Access Compliance Report Public Rights-of-Way (Curb Ramps)

Main Street: MEADS_AVE Cross Street: RANDALL_ST Location: NE

ADA ID: RPAT220223111256 Ramp Type: Type 3 - Combination 1 Initial Pass/Fail: Fail Overall Compliance: No Severity Score: 2

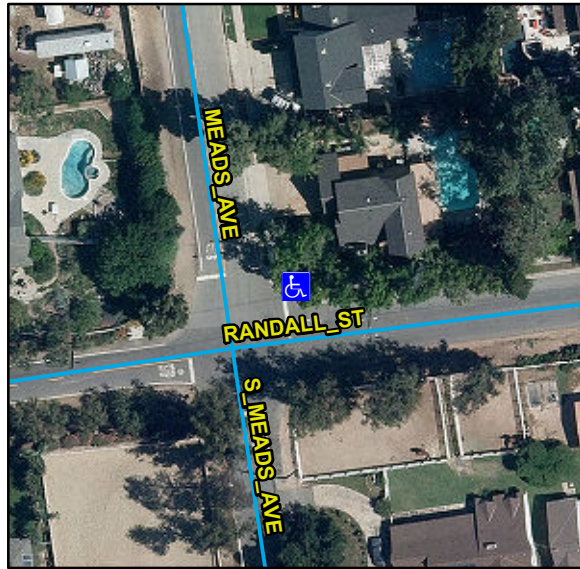
Compliance	Description	Data	Compliance	Description	Data
N/A	Ramp Length LT (in)	74	N/A	Ramp Length RT (in)	110
Yes	Ramp Width LT (in)	54	Yes	Ramp Width RT (in)	52
Yes	Ramp Run Slope LT (%)	4	Yes	Ramp Run Slope RT (%)	6.6
No	Ramp Cross Slope LT (%)	3.4	No	Ramp Cross Slope RT (%)	2.7
N/A	Ramp Length (in)	55	N/A	Flare Type LT	
Yes	Ramp Width (in)	48			N/A
Yes	Ramp Run Slope (%)	8.2	N/A	Flare Slope LT (%)	N/A
No	Ramp Cross Slope (%)	4.2	N/A	Flare Traversable LT	N/A
N/A	Landing Present	N/A	N/A	Flare Type RT	
N/A	Landing Length (in)	N/A			N/A
N/A	Landing Width (in)	N/A	N/A	Flare Slope RT (%)	N/A
N/A	Landing Run Slope (%)	N/A	N/A	Flare Traversable RT	N/A
N/A	Landing Cross Slope (%)	N/A	N/A	DWS Provided	N/A
N/A	Landing Movement Obstructed?	N/A	N/A	DWS Contrast	N/A
	Landing Movement Type	N/A	N/A	DWS Length (in)	N/A
N/A	Landing Shared	N/A	N/A	DWS Full Width	N/A
N/A	Clear Space	No		DWS Offset Type	N/A
N/A	Clear Space To Crosswalk (in)	N/A	N/A	DWS Offset Left (in)	N/A

Remove & Replace Curb Ramp With Two New Directional Ramps or Equivalent.

R304.2.2, R304.5.3, STD 1115
